UNITED STATES
NUCLEAR REGULATORY COMMISSION
WASHINGTON, D. C. 20555

BRUNSWICK STEAM ELECTRIC PLANT, UNIT 2

AMENDMENT TO FACILITY OPERATING LICENSE

Amendment No. 168
License No. DPR-62

Figure 2.2.1-1. APRM Flow Bias Scram Relationship to Normal Operating Conditions

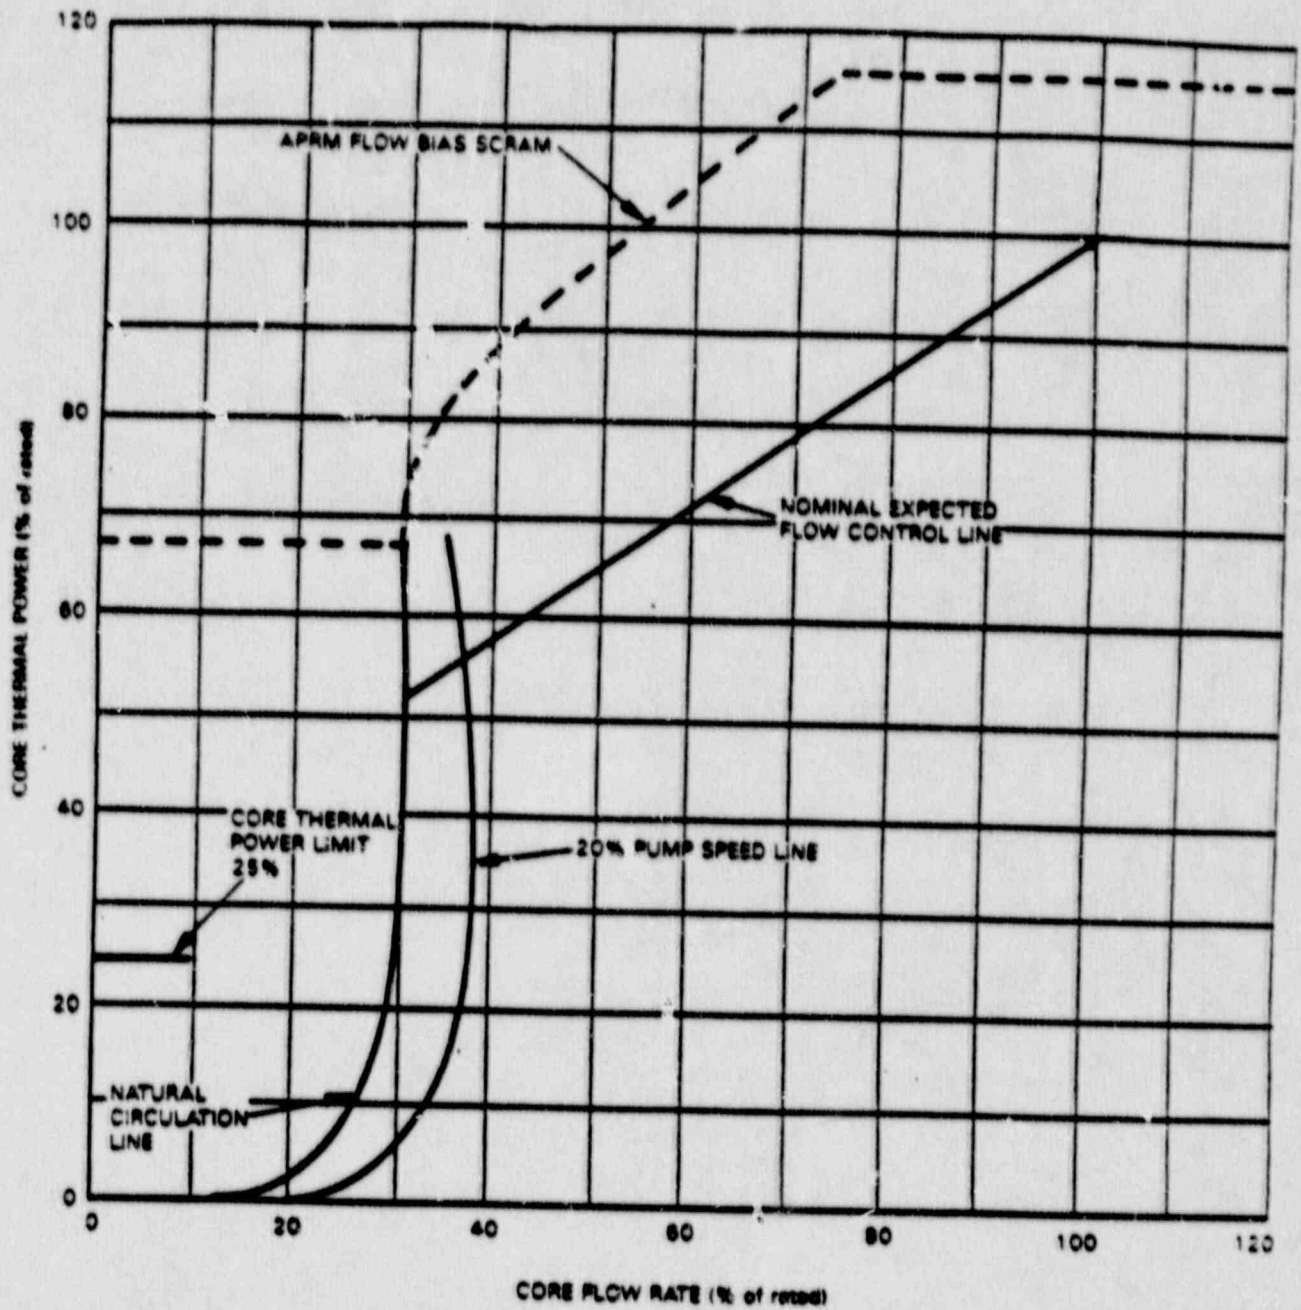
- (b) This Average Power Range Monitor scram function is a fixed point and is increased when the reactor mode switch is placed in the Run position.
- (c) The Average Power Range Monitor scram function is varied, Figure 2.2.1-1, as a function of the fraction of rated recirculation loop flow (W) in percent.
